**PROBLEM:**

There have been occasional reports of the gear change lever sticking on the Z1. It can stick either on upshift or downshift, making it impossible to select another gear. The lack of clearance between the gear change lever and the raised boss on the inside of the transmission cover is the source of the problem.

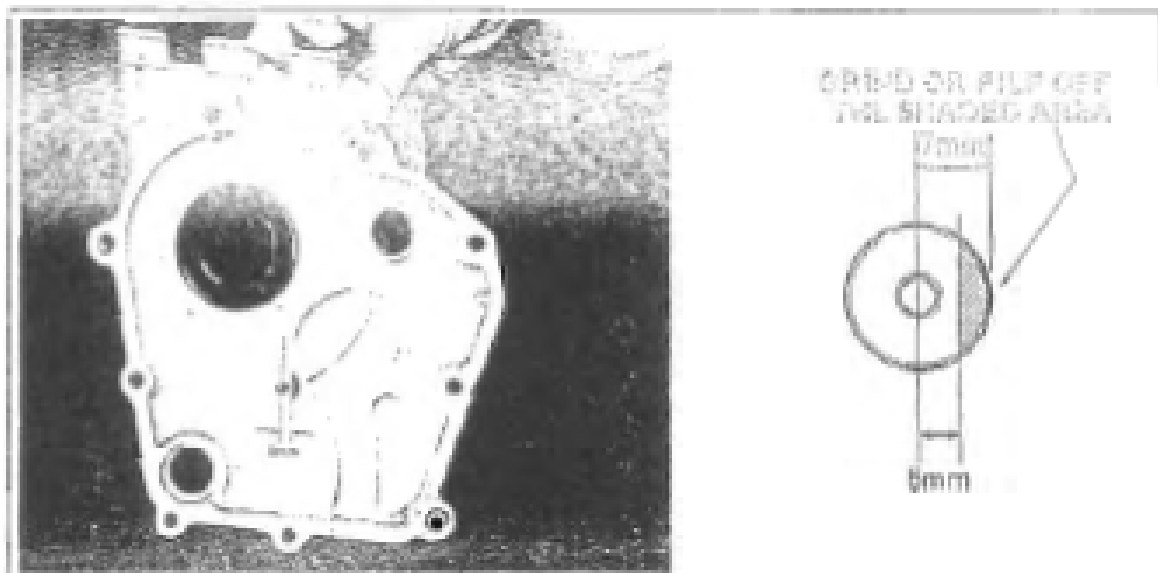
A design change has been made in the transmission cover from engine number Z1E-20428 to prevent this problem on future models. The new cover has a smaller diameter boss, reduced from 14mm to 10mm, thus increasing the clearance to the gear change lever.

If this sticking problem should occur on earlier Z1's, modify the cover in the following manner:

Grind or file the raised boss as shown.
